STAFF REPORT
COMMUNITY DEVELOPMENT DEPARTMENT

SUBJECT: H-2020-0067
Jocelyn Park Subdivision

Request for Preliminary Plat approval of 67 single-family residential lots and 7 common lots in an existing R-8 zoning district.

A. Revised Preliminary Plat (dated: ~~July 17, 2020~~ ~~9/08/2020~~ 10/14/2020)

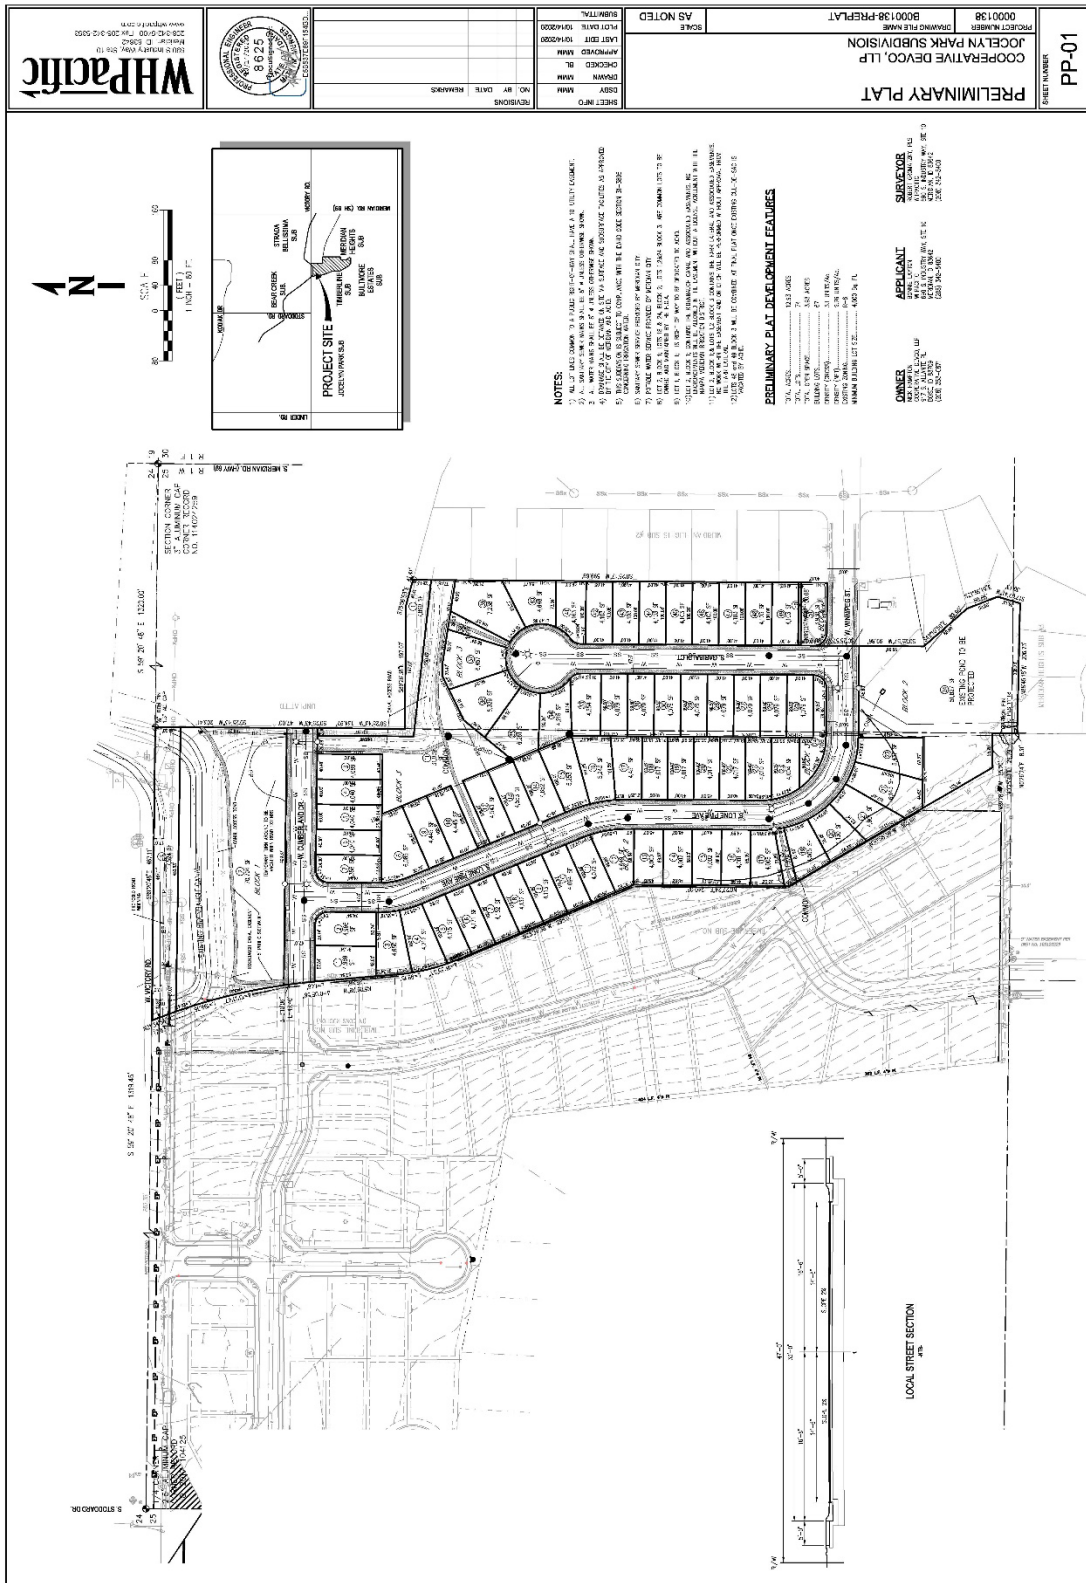
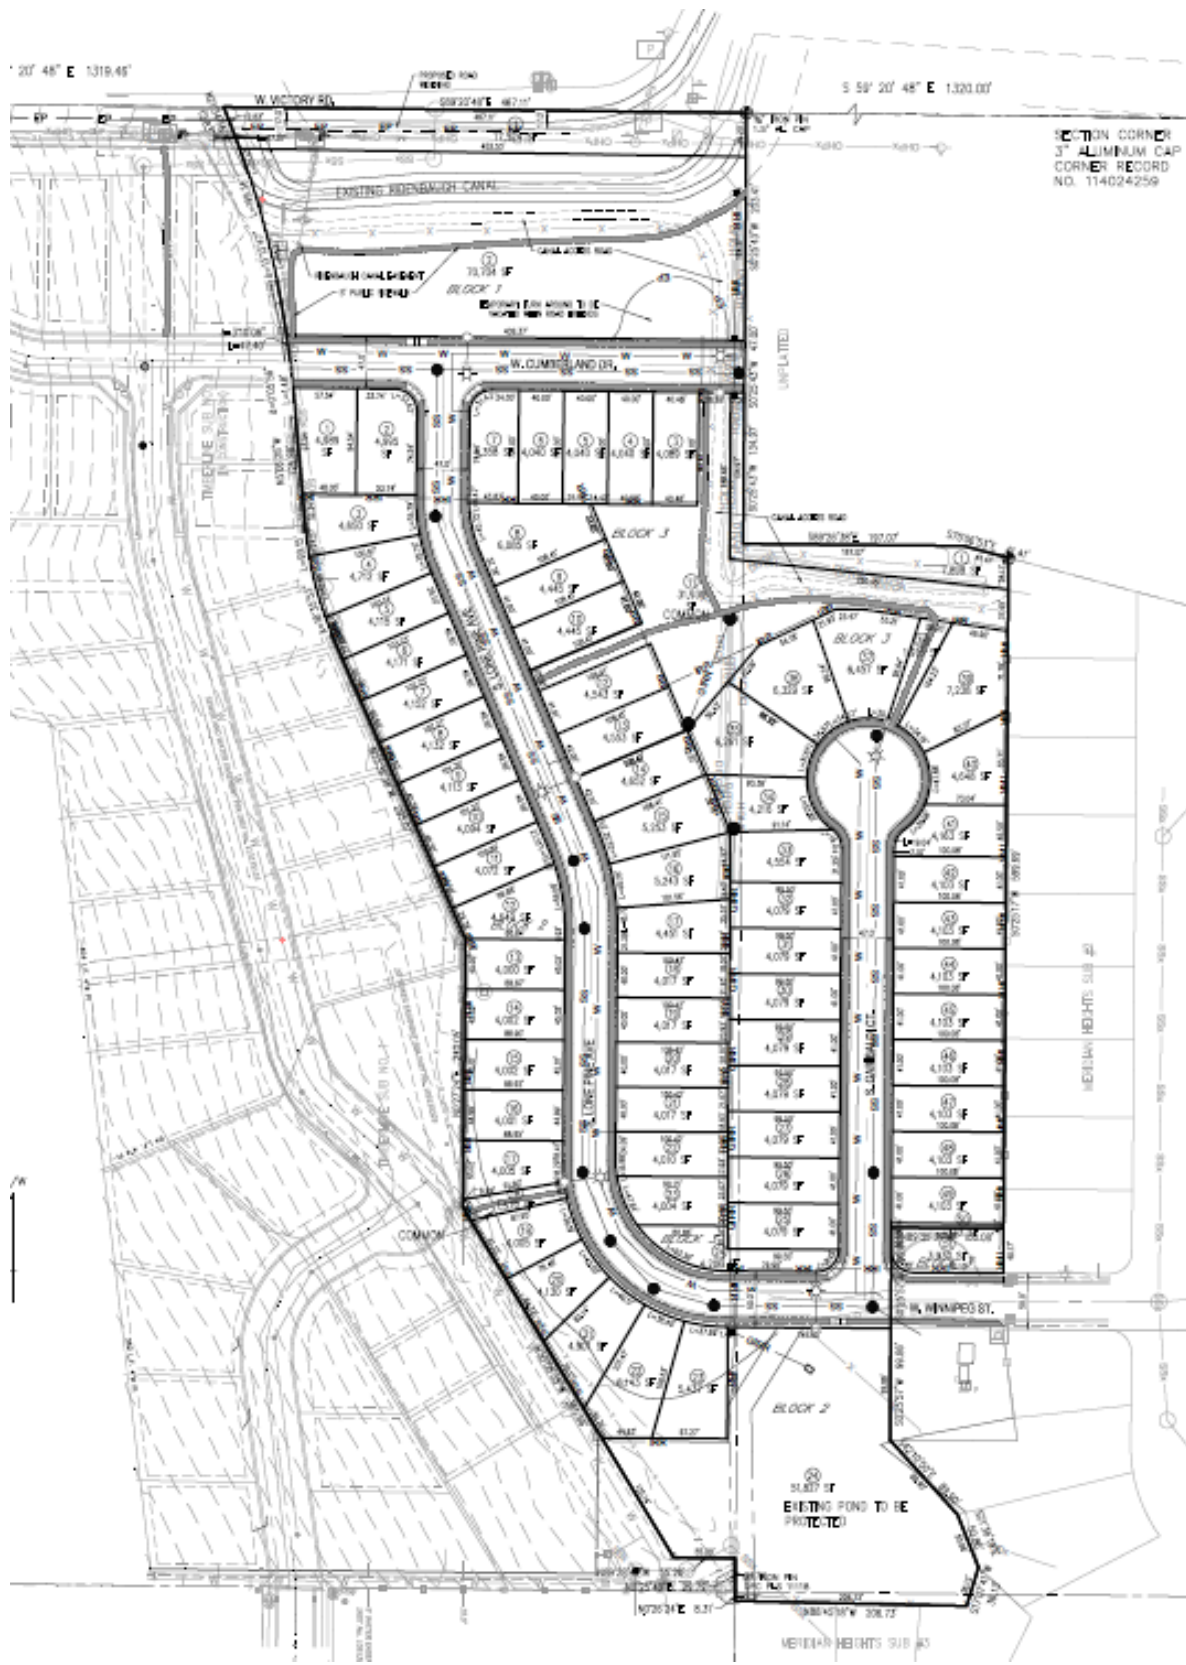
Furthermore, the adjacent property owner to the northeast has a shed that is actually on the subject property. The Applicant has created a specific lot (shown as Lot 1, Block 3) in the plat in order for the adjacent property owner to later purchase the property and correct the boundary dispute. Staff supports and appreciates this consideration from the property owner regarding this property boundary issue.

Staff supports the addition of micro-pathways throughout the development but has some concerns regarding their placement. First, Staff believes the micro-path connection from the central open space lot to the western street should be relocated two lots further north, between Lots 10 & 11, Block 3 to help with potential visibility issues and crime prevention. Second, Staff has concerns over how the pathway within the large open space lot along the Ridenbaugh Canal is depicted on the submitted plans and where it shown to connect to the Timberline Subdivision to the west. The Timberline lot directly abutting the subject site in the northwest corner is a buildable lot and will have a privacy fence on the shared property boundary. Therefore, the proposed layout of the pathway shown would likely never become a reality. The only other pedestrian access out to Victory Road from this site would be via the irrigation district access road but this is not supported by staff nor the irrigation district at this time. This access road will likely be fenced off from this open space lot to ensure a safer open space area along the canal. Because of these issues, staff proposes that the proposed pathway be completely out of the irrigation district easement and looped around this northern open space lot for a walking path around the perimeter of the lot and connect back to the proposed sidewalks along the extended W. Cumberland Drive.

1. The revised preliminary plat included in Section VII.A, dated ~~July 17~~October 14, 2020, is approved as submitted, shall be revised as follows at least ten (10) days prior to the City Council hearing:

- a. ~~Revise the plat to include some of the area behind~~ rotate Lots 35-37 and 36, Block 3 ~~to the west and subsequently move the proposed micro-pathway to the east to make the open space area behind them more usable and accessible;~~ as part of these building lots instead of common open space up to the boundary of the irrigation district easement.

OPEN SPACE EXHIBIT

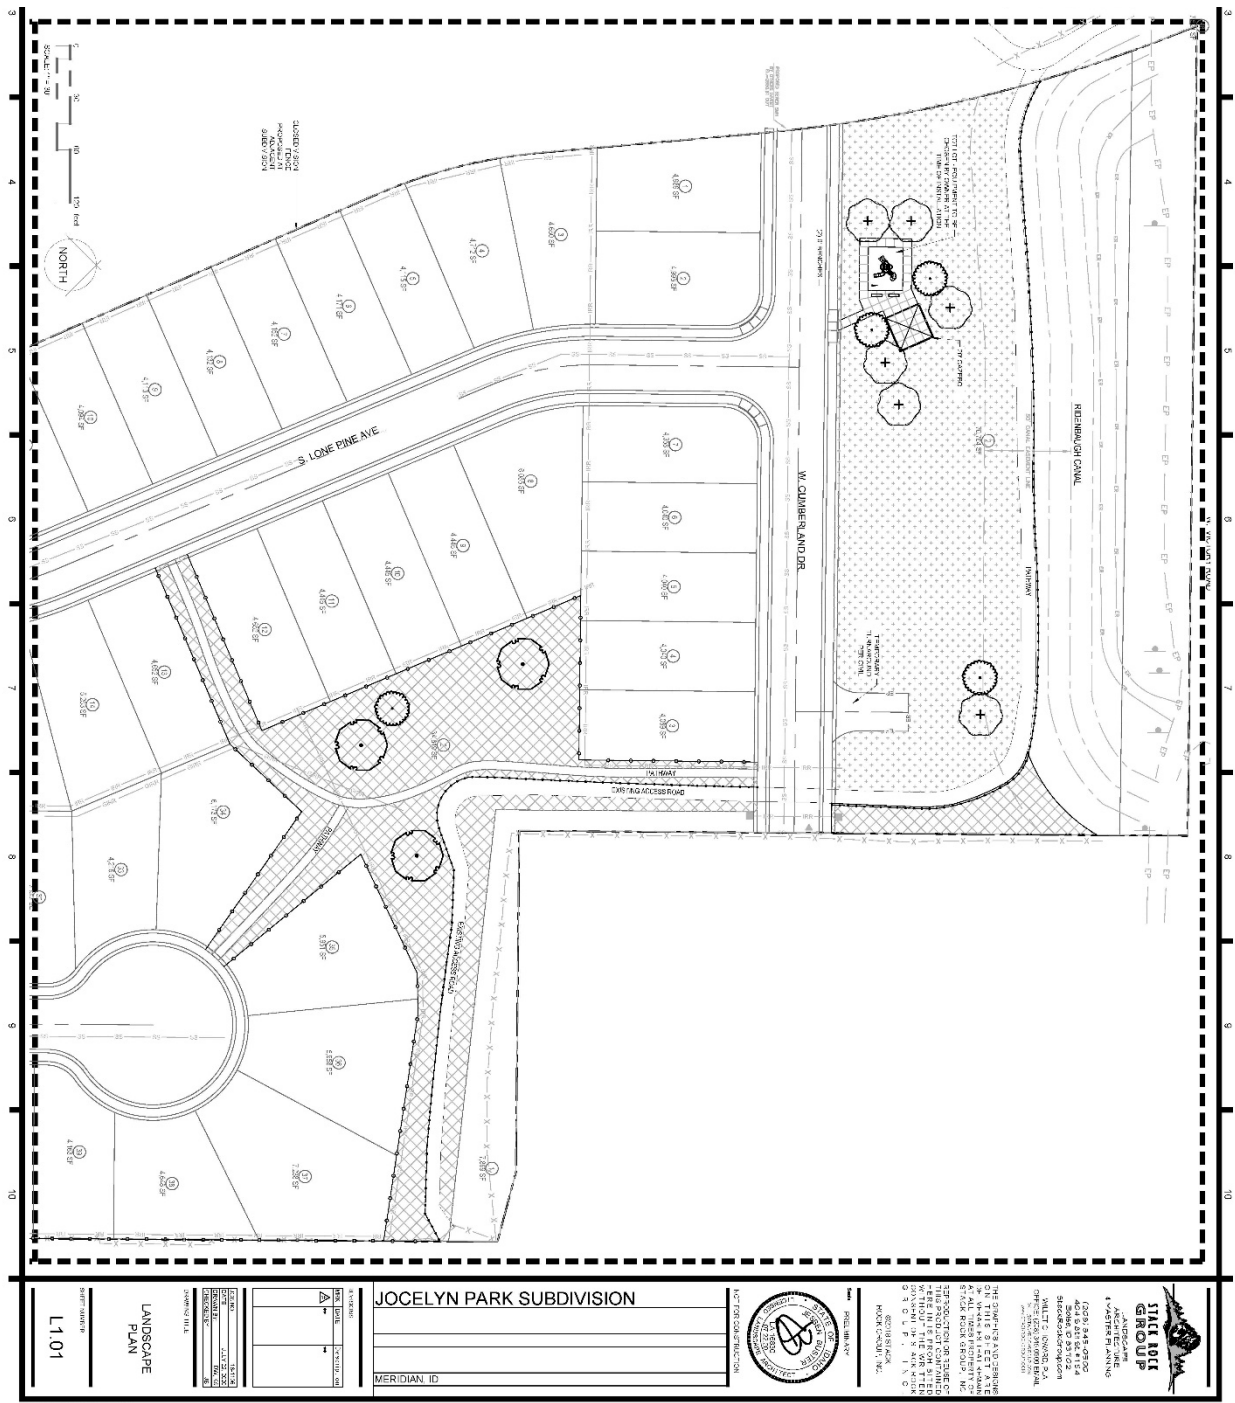
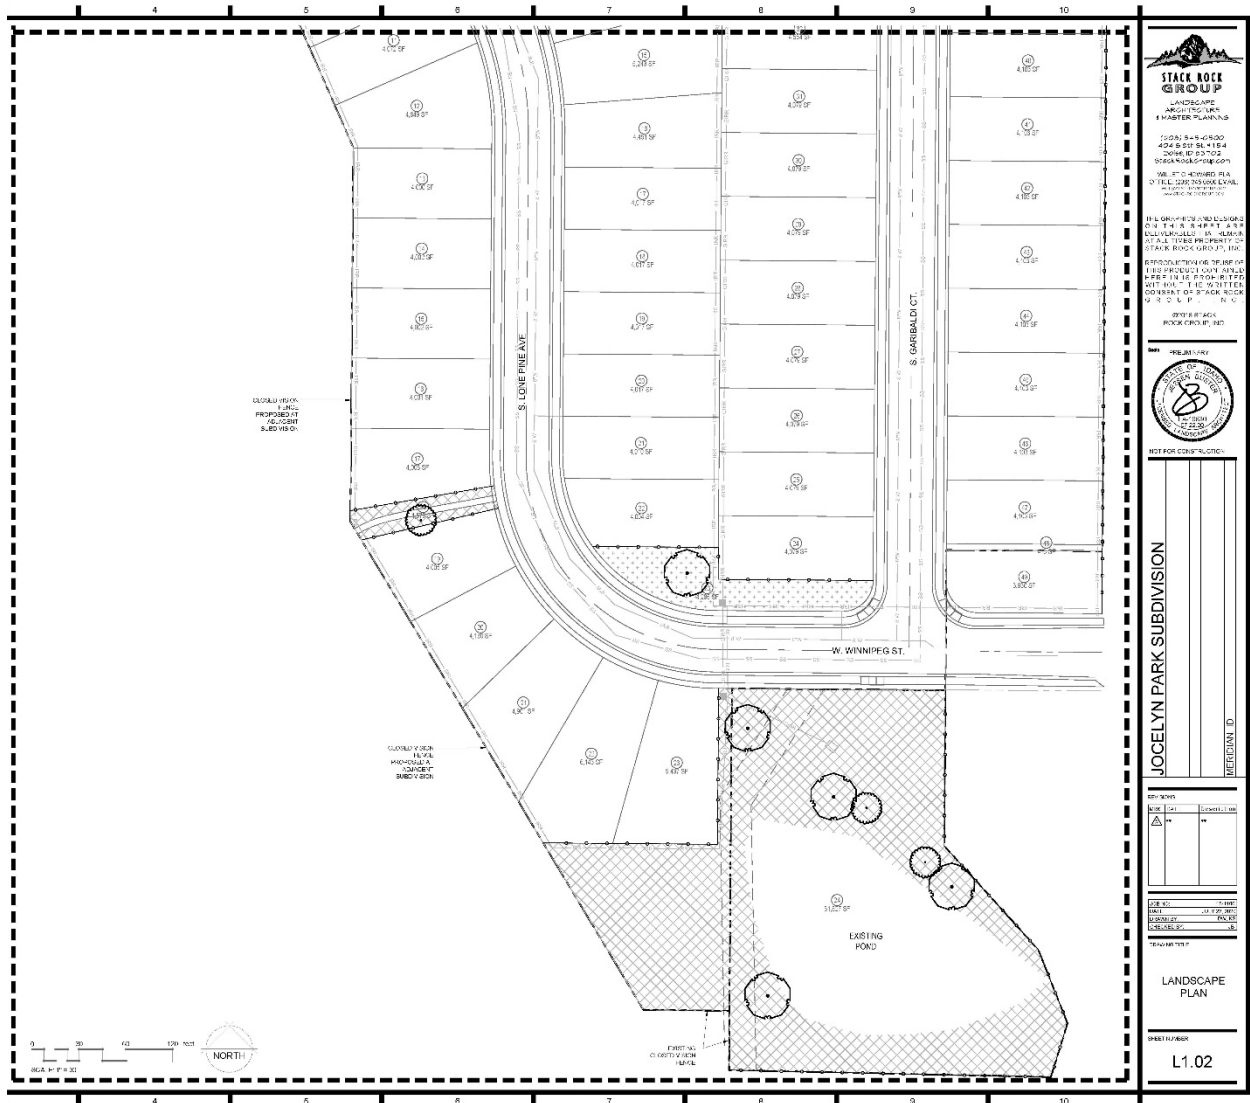
According to the open space exhibit (see Exhibit VII.B), the applicant is proposing a total of 3.65 acres of open space. The exhibit shows three (3) distinct areas of open space: one area in the south that contains the pond; one area along the entire northern boundary of the subject site; and one centralized area. The large open space lot containing the pond abuts open space area in the Timberline No. 1 subdivision currently under construction. In addition, there is an end cap lot and a micro-pathway connection to the west shown on the open space exhibit. The submitted open space exhibit shows all of this area as qualifying but upon Staff's review, some of this area is not qualifying.

The existing pond is more than 25% of the lot in which it resides and therefore the entire lot is not qualifying open space per the standards listed in UDC 11-3G-3B.7. The other area of open space that is listed as qualifying but is indeed non-qualifying is the end cap lot located at the south end of the lot (approximately 4,200 square feet) directly north of the pond. This area meets neither the 50' by 100' dimensions nor the 5,000 square foot minimum size in order to count towards the qualified open space. After removing the end cap lot and the lot containing the pond from the open space calculations, there are 2.46 acres of area that is all qualifying open space. Staff is recommending a condition to revise the open space exhibit prior to the City Council hearing to ensure a clean record.

An area of additional concern for Staff is the open space area directly north of Lots 35-37, Block 3 (the lots at the end of S. Garibaldi Court in the eastern half of the site). The Applicant is proposing to leave an area of open space between the rear yards of these three homes and the irrigation district access road. The access road must be fenced off from this development which leaves a thin area behind homes with the only true visibility coming from the open vision fencing of these three homes' rear fence. This area leads to nowhere and does not appear to offer any usable benefit for the development if left as is. Even with the required open vision fencing along the rear of these lots, Staff is concerned this area of open space will be neglected due to the slope of the terrain and its location. Therefore, Staff is recommending that this area be added to the adjacent lots, Lots 35-37, Block 3, instead of remaining open space. The open space calculations should then be revised to remove this area from the calculations table.

- a. Revise the calculations table to show the correct amount of qualified versus non-qualified open space in accord with UDC 11-3G-3.
 - b. ~~Revise the open space exhibit to show and calculations table to remove that area behind~~ Revise the open space exhibit to show and calculations table to remove that area behind Lots 35-37 and 36, Block 3 rotated to the west and the micro-pathway relocated to the east to match the revised preliminary plat layout up to the boundary of the irrigation district easement.

- c. Revise the open space calculations to remove that area where the required temporary turnaround is located on the common open space lot, Lot 2, Block 1.

- d. Revise the open space exhibit to reflect the revised plat layout.
- ~~4. At least ten (10) days prior to the City Council hearing, the Applicant shall revise the preliminary plat, landscape plans, and open space exhibit to show the proposed pathway in the northern open space lot (Lot 2, Block 1) as completely separate from the irrigation district access road and loop through the open space lot to connect back to the proposed W. Cumberland Drive in the northwest corner of the site.~~
